Staff Presentation to the
Portland Design Commission

Design Review Hearing
LU 15-251943 DZ
Grant Park Village II

April 14, 2016

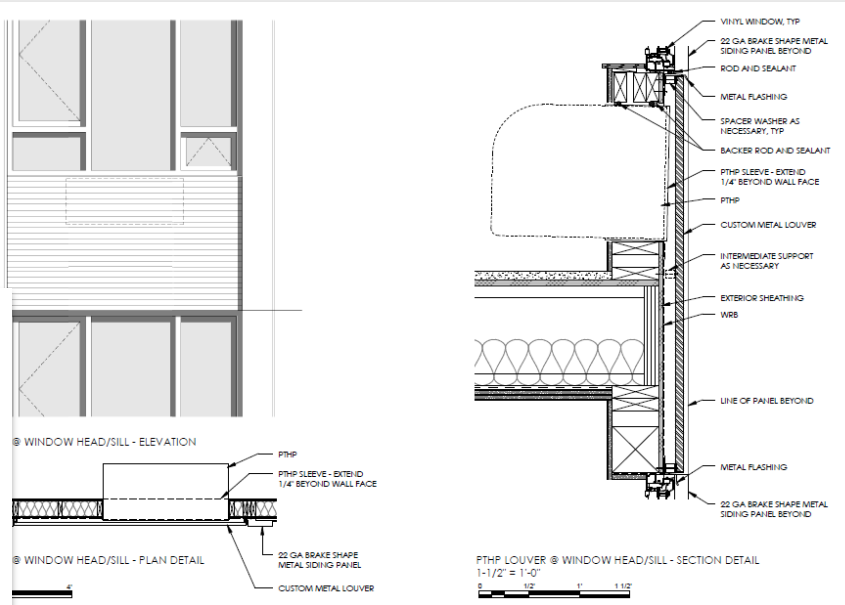
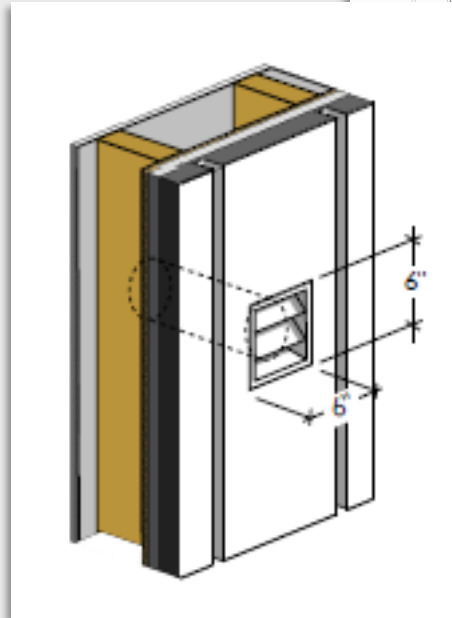
Active ground floor use has been added on the east elevation creating a more “active bar” fronting the central plaza and Arnston Yards. Vehicular access is now limited to the south end of the east bar and no at-grade parking/loading is proposed. All parking related program is below grade.

Staff is supportive as proposed that this degree of response is compliant with applicable Approval Criteria. Please refer to Sheets 11, 12, 16 and 33.

Ground Floor Residential Units

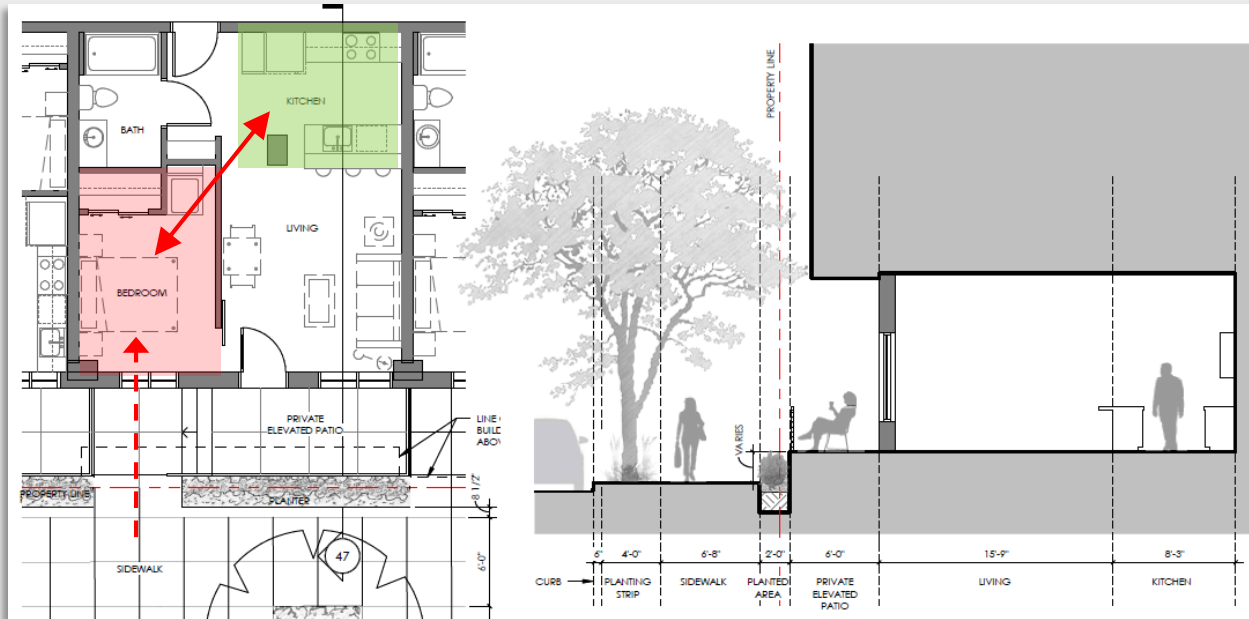
Unit plans indicate bedrooms oriented to exterior walls adjacent to the entry stoops. Staff is concerned that orienting the most inactive of residential floor area to exterior glazing will result in drawn blinds, thereby not sufficiently activating the public realm. Locating more active floor area (like kitchens) to the exterior walls would better enhance the project's public frontage and induce greater crime prevention through increased surveillance opportunities.

Bedrooms shall not be located on exterior walls of ground floor residential units.
